SERVICE BULLETIN

PURPOSE : INFORMATION	ISSUE NO. : MSB-10E22-004	DATE : 2010-12-05
SUBJECT : TC-SST SERVICE PROCEDURES		<MODEL> (EUR) OUTLANDER (CW0W) <M/Y> 10, 11
GROUP : MANUAL TRANSMISSION

Attached sheet 1

DISASSEMBLY AND REASSEMBLY

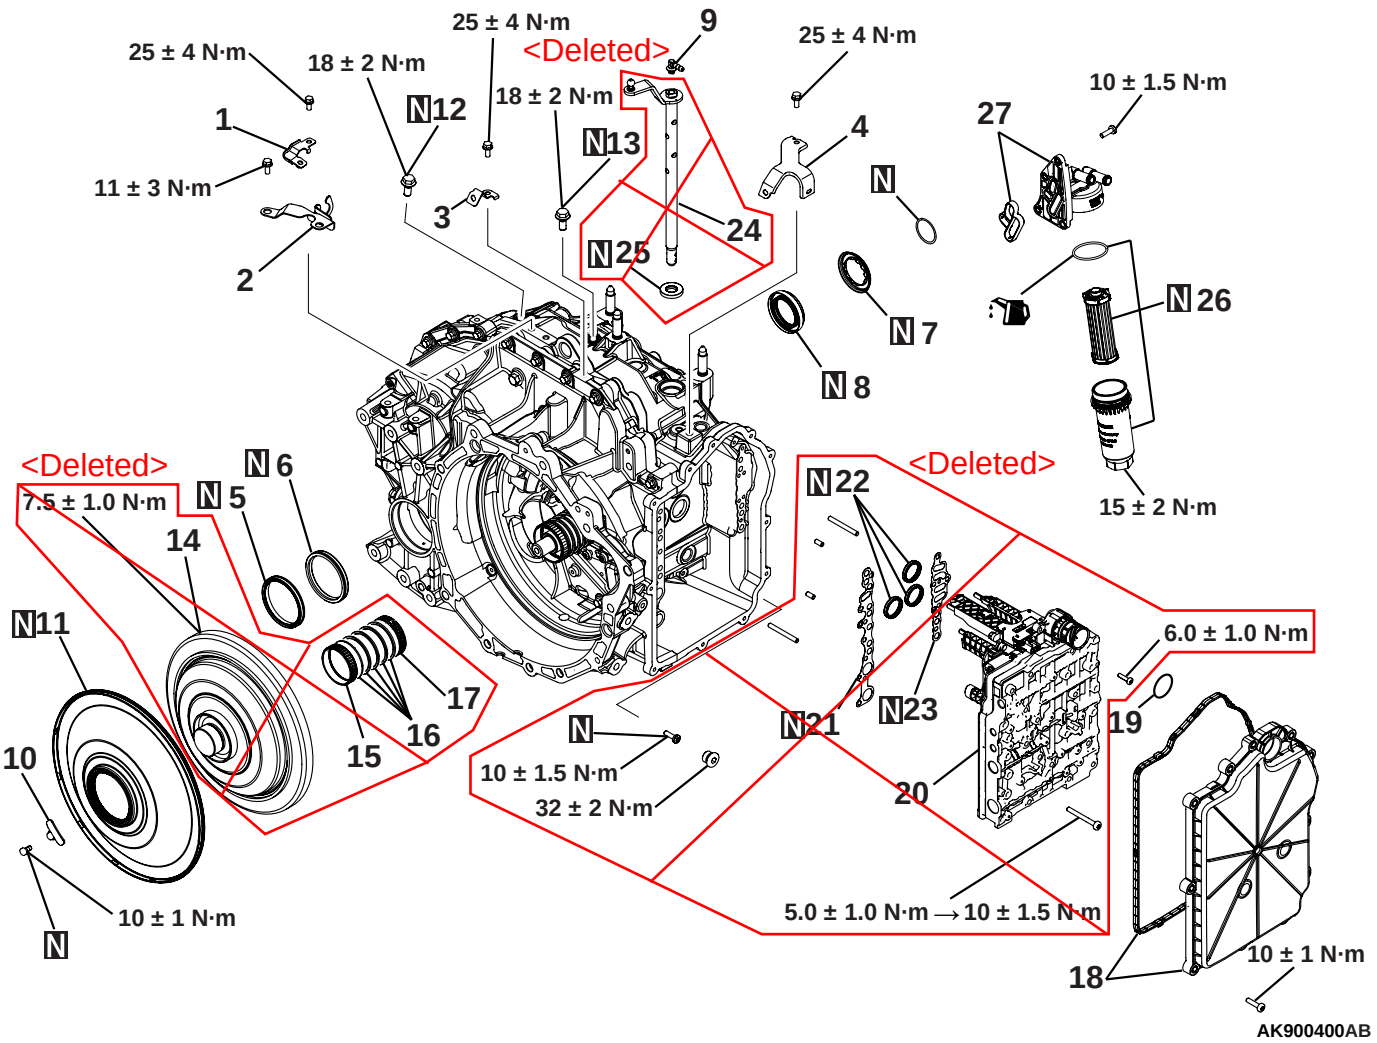
<Deleted>		Disassembly steps (Continued)
<<F>>	>>F<<	14. Clutch assembly
		15. Needle roller bearing
	>>E<<	16. Seal ring
	>>D<<	17. Needle roller bearing
<<G>>	>>C<<	18. Oil pan assembly
<Deleted>		19. O-ring
<<H>>	>>B<<	20. Mechatronic assembly
	>>B<<	21. Gasket A
		22. Gasket B
	>>B<<	23. Gasket C
<<I>>	>>A<<	24. Manual control shaft
		25. Oil seal
		26. Oil filter case assembly
		27. Oil filter bracket assembly
